COUNCIL SUBMISSION

SSD 10459 – CENTRAL SYDNEY INDUSTRIAL ESTATE AND DOWNER SUSTAINABLE ROAD PRODUCTS COMPLEX

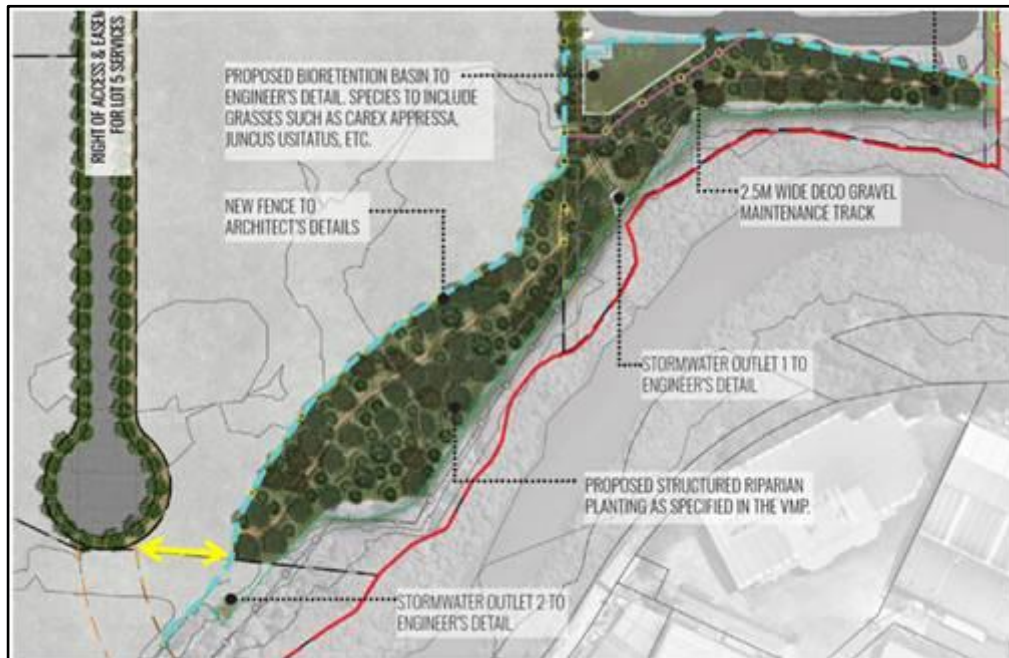
- The new entry road is to be designed as a public road using minimum kerb radii to achieve required swept paths, central road median removed, general road cross-section dimensions including footpath, verge, car parking, travel lanes. The set out of the western side of the new road should anticipate possible future footpath min 1800mm wide

- Upgrades to south side of Devon St should be shown including new footpath, minimum width of 1800mm, street trees and landscape verge for the full extent of the street frontage, and bicycle path requirements

- A statement should be provided confirming landscape treatment, including tall canopy trees, can be achieved within the 5m services easement
- The bicycle path in the new road easement should connect to the foreshore 3m path within riparian zone and the cycle path at Devon Street

- The new road design should consider the option for additional street trees in the parking spaces using WSUD technologies
- New stormwater and services to be designed so as not to inhibit planting of street trees, in the verge and or car parking spaces;

- At the riparian zone/edge boundary, the retaining wall should be stepped with landscape to reduce visually vertical scale of wall and the 1800 high fence at the top of the wall.
